Aren 15

CITY OF LAS VEGAS		DATE:
INTER-OFFICE MEMORANDUM		October 17, 2017
TO: Land Development Services Department of Building & Safety		FROM: Albert Sung, P.E. Flood Control Project Engineer Department of Public Works
SUBJECT:	Drainage Study for:	COPIES TO:
	Area 15	Kimley Horn and Associates, Inc.
Cross Streets:	SWC of Rancho drive & Sirius Avenue	Integral Partners Park Center Las Vegas, LLC
File Number:	F:\Depot\DSMemos\DS4921A.doc	Bart Anderson, P.E., DevCo
Parcel Number:	162-08-418-002	CCRFCFCD
Zoning Action:	SDR-70652	NDOT
FEMA Flood Zone	YES	NO X
Proposed Storm Drain	YES	NO X

Technical Drainage Study

Area 15

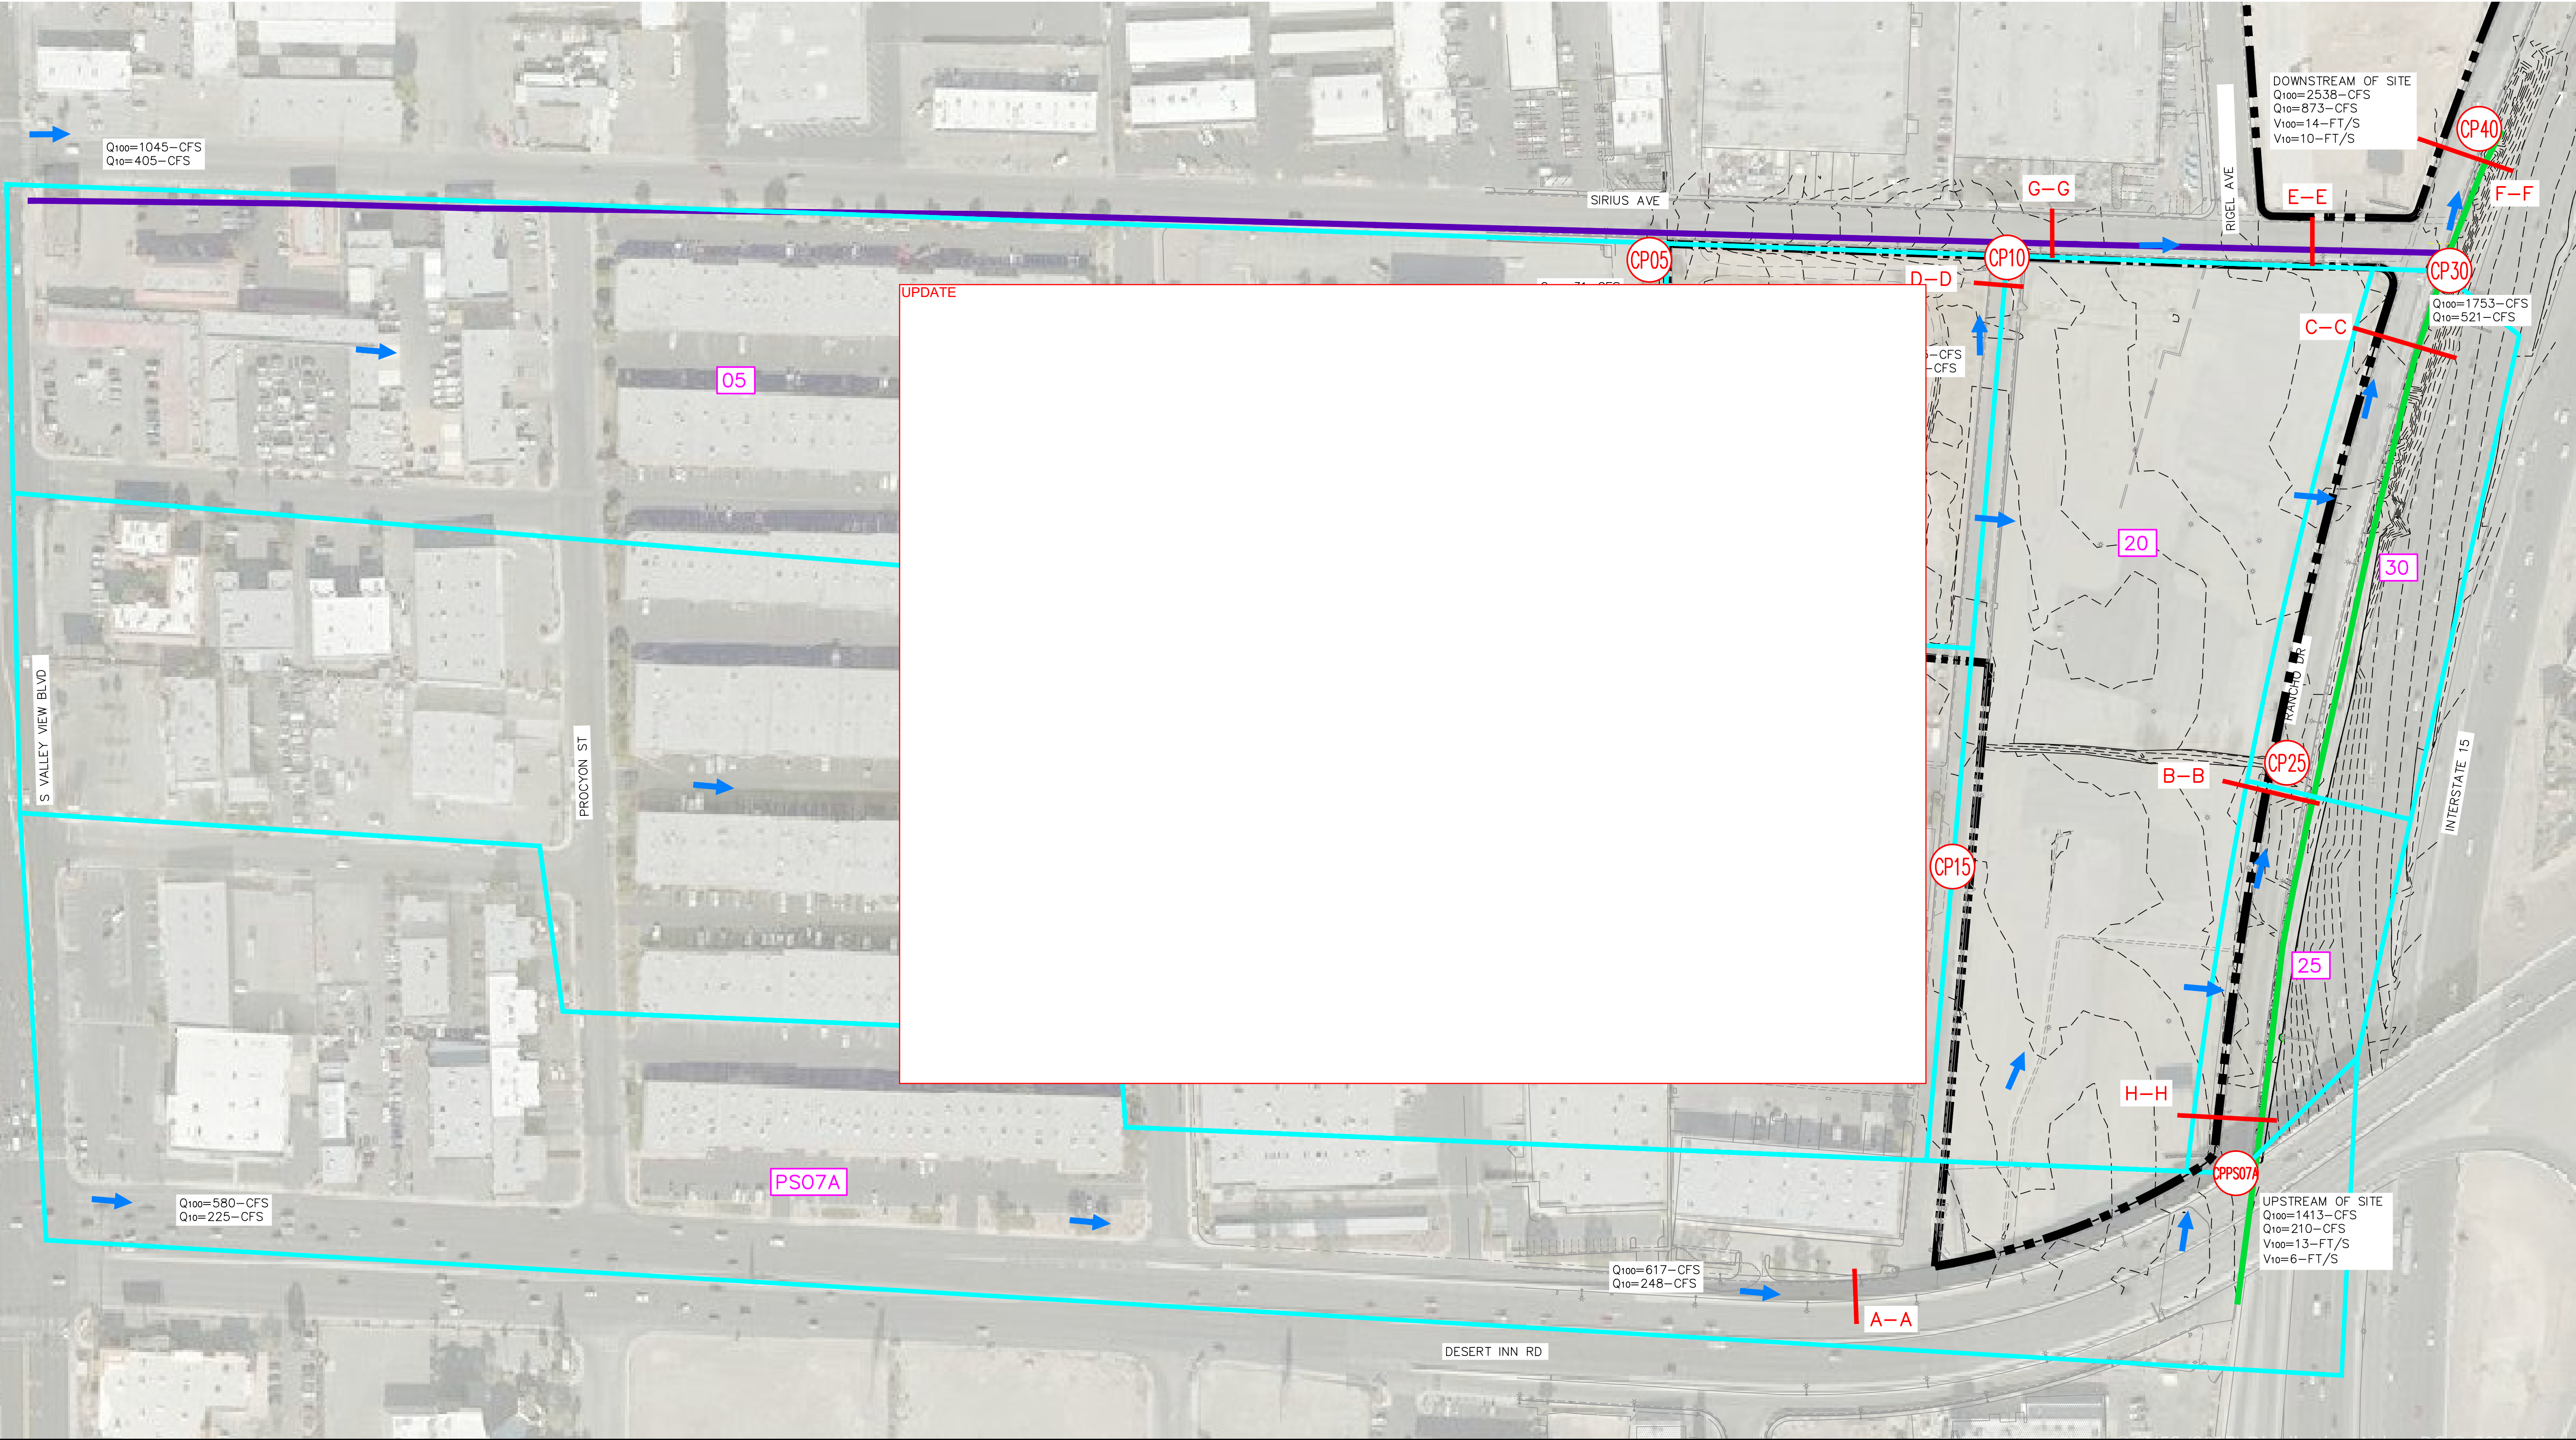
4. **Existing Conditions Exhibit:** Basin 05, Basin 15 and Basin PS07A are developed areas. In Las Vegas valley, Q_{100} is generally at least 2cfs/acre. But all the basins in the **Exhibit** show as low as 1.5 cfs/acre which is unreasonable. Review and revise the hydrology and the Q_{10}/Q_{100} parameters table accordingly.

5. **Existing Conditions Exhibit:** In the "Existing Condition" Table, "CPPS07A" is shown to have $Q_{10}/Q_{100} = 480/1683$ cfs. However, in the map at the intersection of *Rancho Drive* and *Desert Inn Road* shows a huge discrepancy of $Q_{10}/Q_{100} = 210/1413$ cfs. Review and revise the **Exhibit** and all pertinent hydraulic sections and calculations accordingly in the next submittal.

9. Provide *Warning Sign Post* for the parking lots within the inundation limit on the grading plans.
10. Per the **Existing Conditions Exhibit**, a $Q_{100} = 46$ cfs impacts at the southwest corner of the proposed building. It appears that the flow will split into north and east directions around the building. Provide section calculation to prove that the proposed FFE is adequate.

15. Along *Rancho Drive* the cross sections provide a flow of 1413 cfs at cross section H-H, it then increases to 1562 cfs at cross section B-B, and finally decreases to 1355 cfs at cross section C-C. Per **Existing Conditions Exhibit**, the flow should transition from 1413 cfs, collect the flow from CP15, and basin 25 and increase to 1462 at cross section B-B. Finally, it should collect from basins 20 and 30 to increase to 1482 at cross section C-C. Per the hydrology, please clarify the flow values provided at sections H-H, B-B, and C-C.

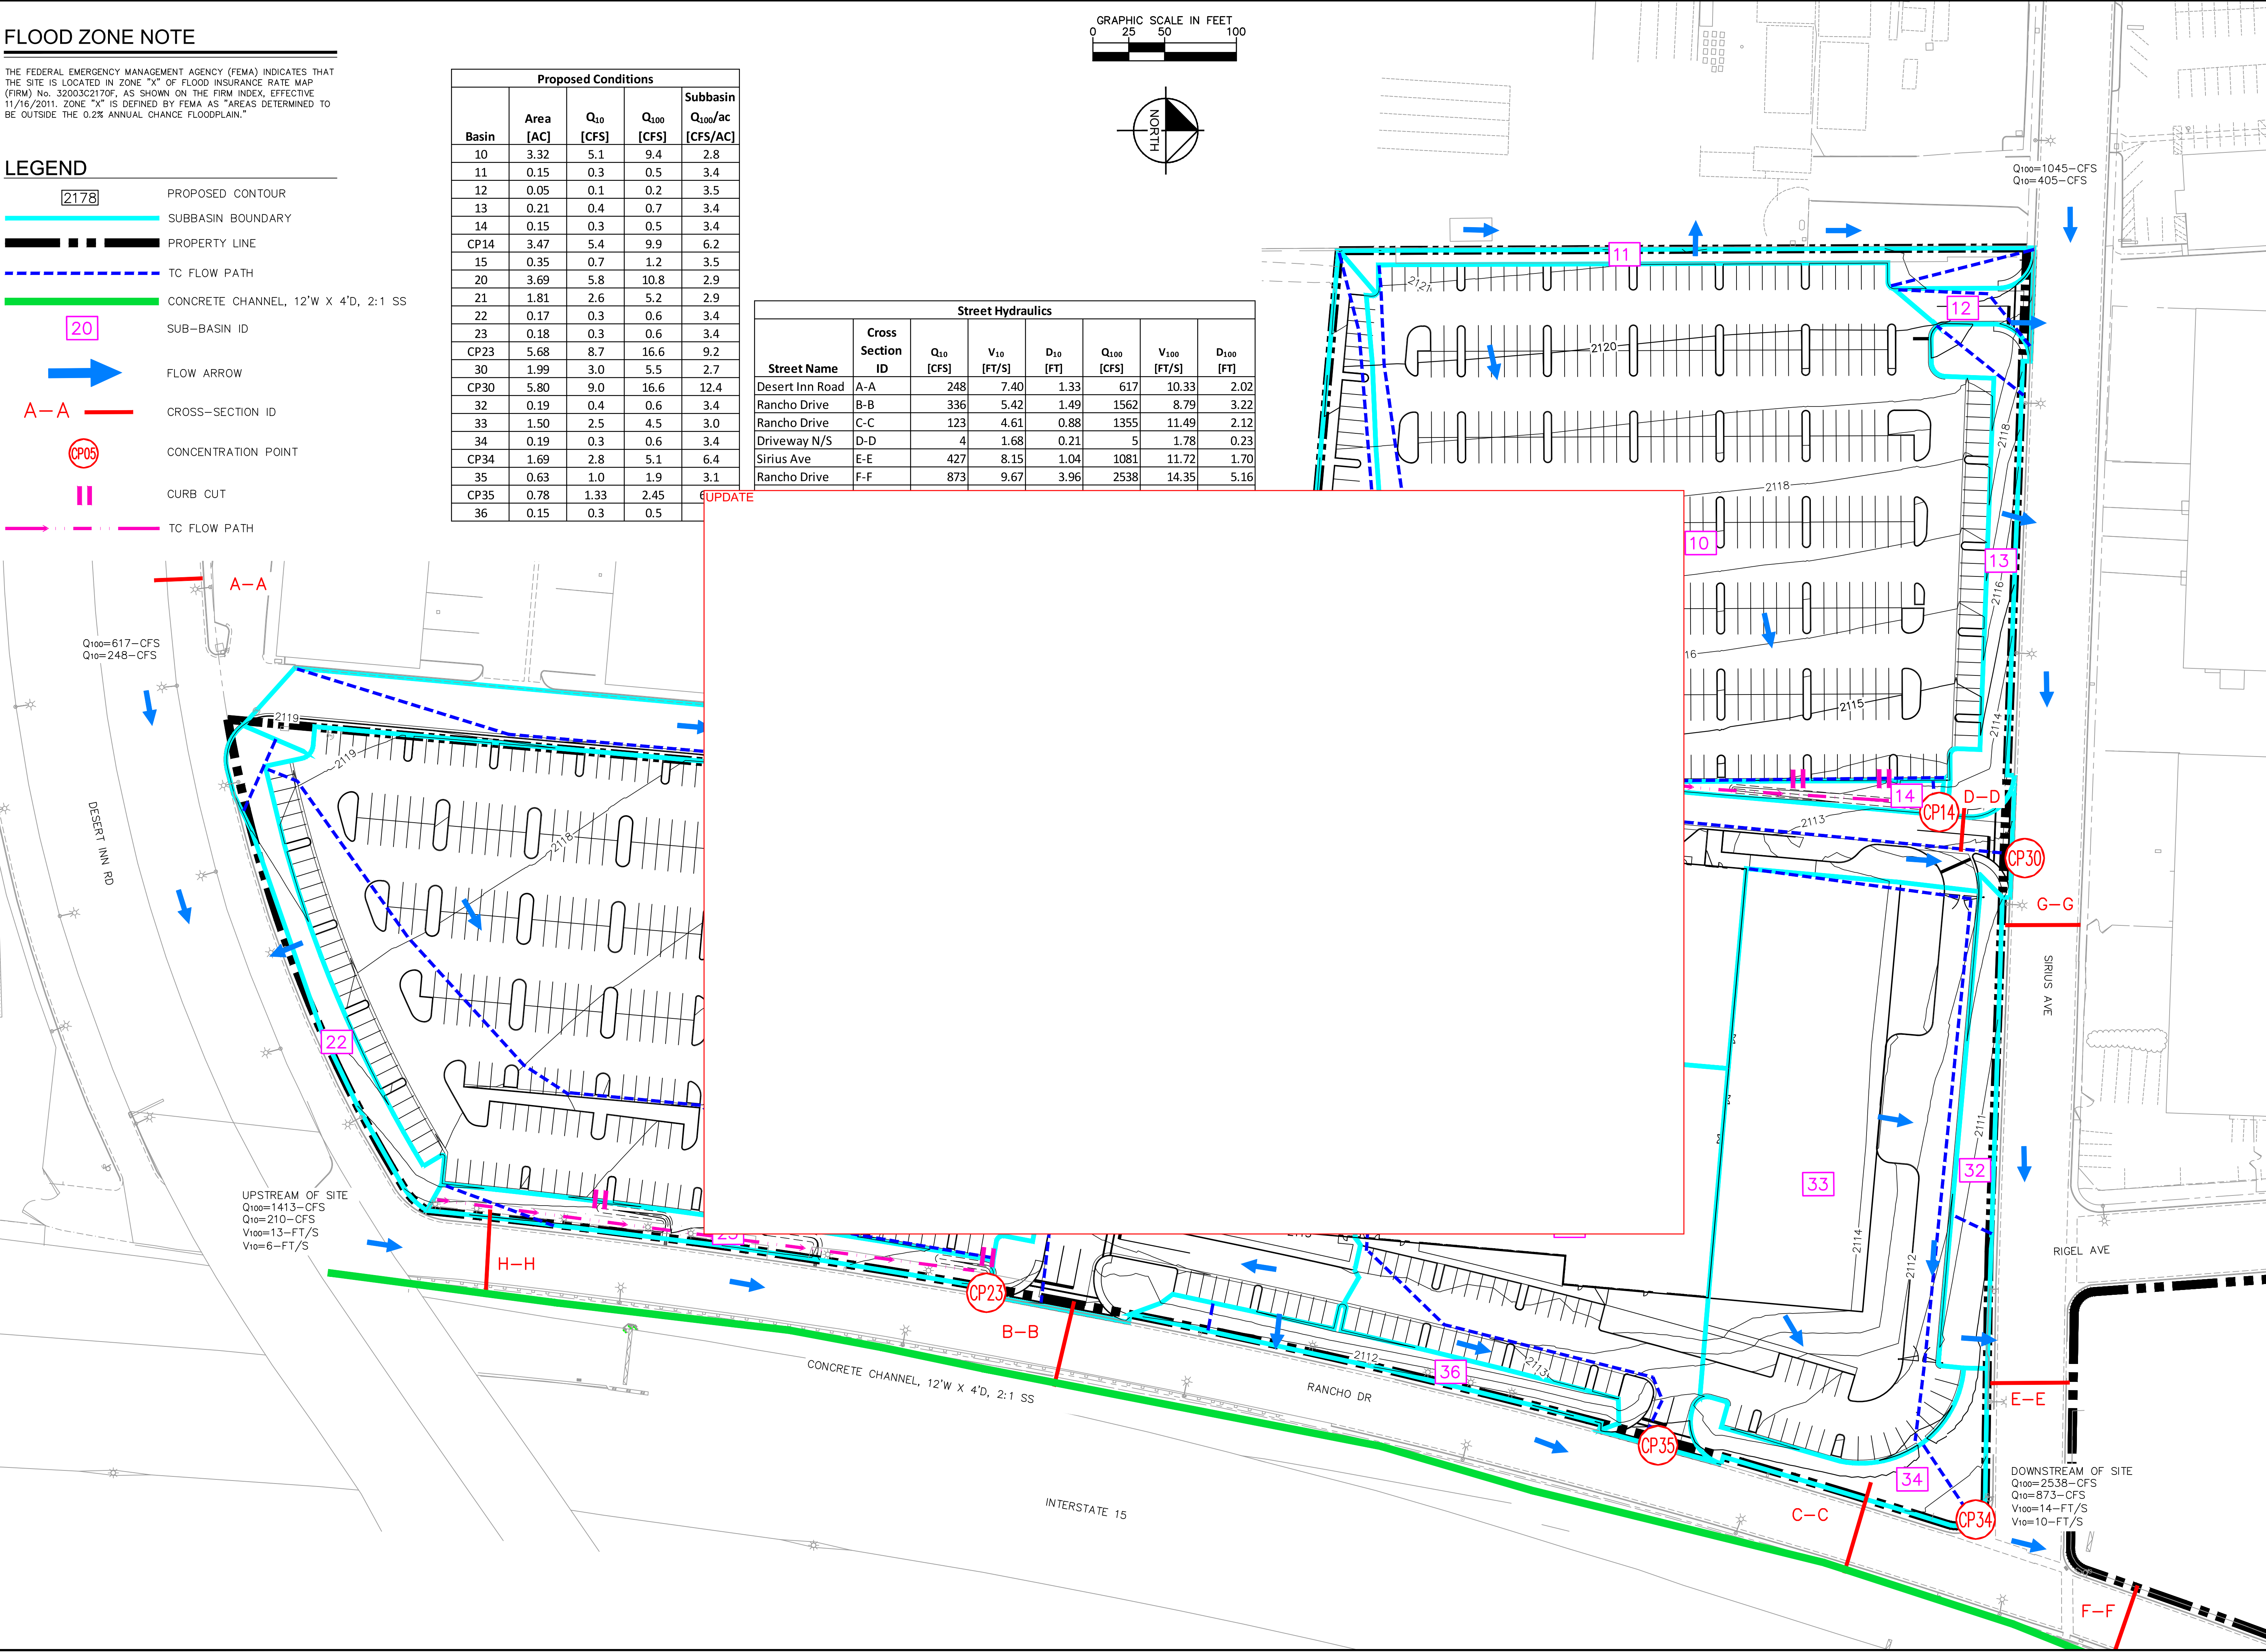
6. The above comment applies to the **Onsite Proposed Conditions Exhibit** also.
7. The *Haestad Methods* hydraulic calculations presented in the last submittal for all cross sections at *Rancho Drive* did not include the adjacent channel as an integral part of the overall picture. Provide existing and proposed conditions at three locations, the north end, the middle and the south end of the building at *Rancho Drive* with complete cross section starting at the building wall, parking stalls, landscape area, *Rancho Drive*, the existing channel and the adjacent freeway. Justify that the adjacent freeway I-15 will not be negatively impacted.

Show and label the BFE at the three locations on the **Onsite Proposed Conditions Exhibit**.
8. The anticipated 100-year storm event will inundate into the proposed development beyond the right-of-way lines in all three perimeter streets. Delineate the 100-year flood inundation limit on the *Overall Grading Plan* and all the enlarged grading plan sheets.
